EVERSTEAD
SHOP DRAWINGS/SUBMITTAL REVIEW

JOB No.	2783568
DESCRIPTION	SUMMIT HOMES - HAWTHORNE RIDGE #109
JOB ADDRESS	3201 SW ARBORTREE DR
CITY	LEE'S SUMMIT, MO
DESIGNER	TODD W MOORE
DATE	5/27/2021

ROOF
TRUSS LAYOUT

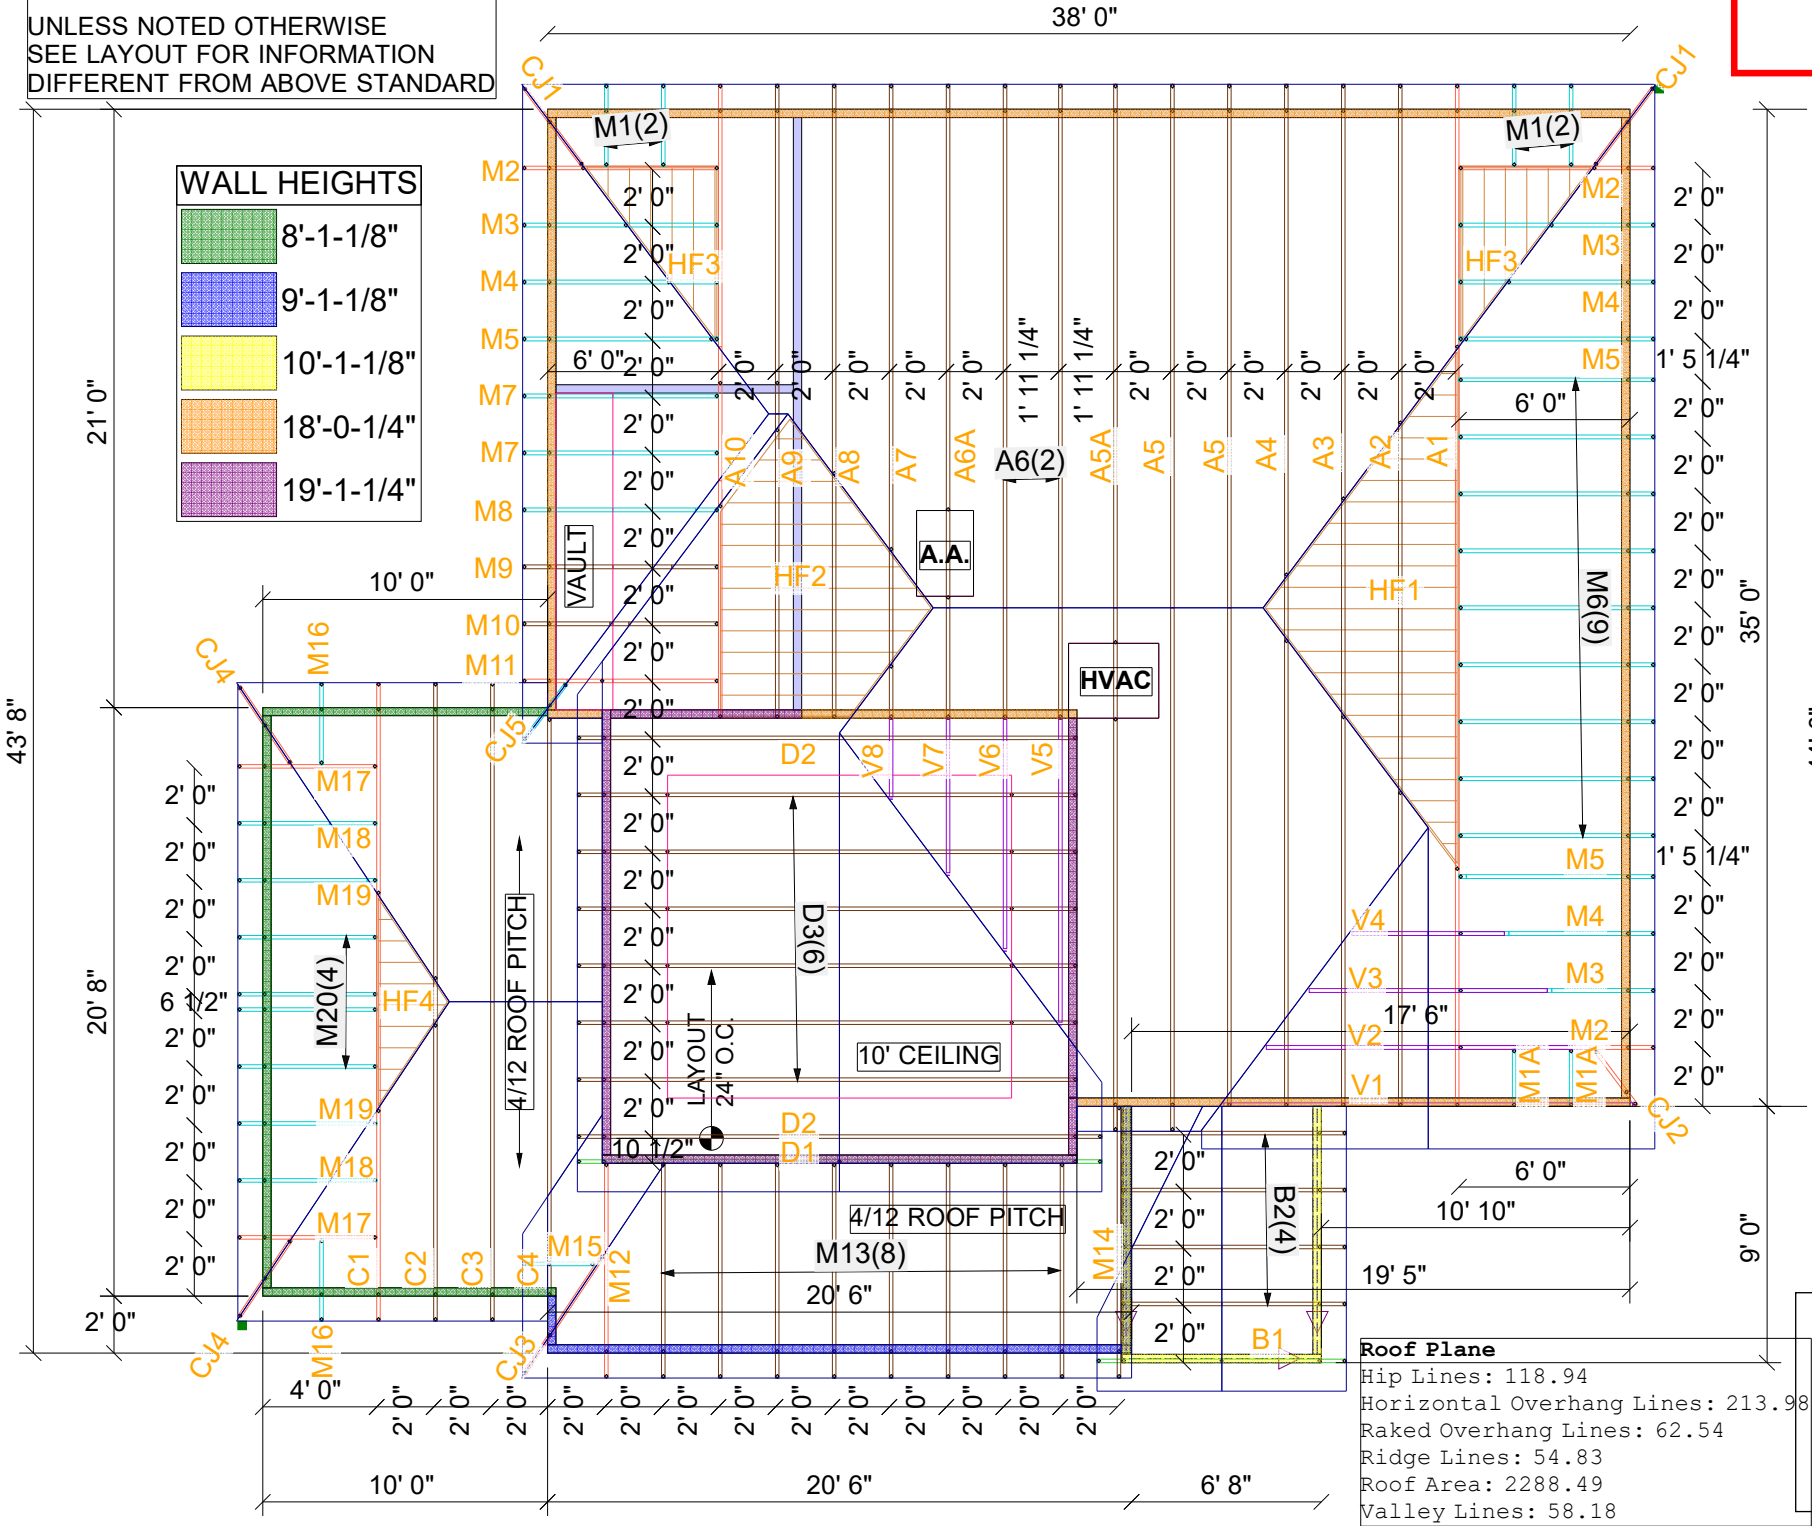
SUBMITTAL WAS REVIEWED FOR DESIGN CONFORMITY AND GENERAL CONFORMANCE TO CONTRACT DOCUMENTS ONLY. THE CONTRACTOR IS RESPONSIBLE FOR CONFIRMING AND CORRELATING DIMENSIONS AT JOBSITE FOR TOLERANCE, CLEARANCE, QUANTITIES, FABRICATION, COORDINATION OF HIS OR HER WORK WITH OTHER TRADES, AND FULL COMPLIANCE WITH CONTRACT DOCUMENTS.

STATUS:

APPROVED
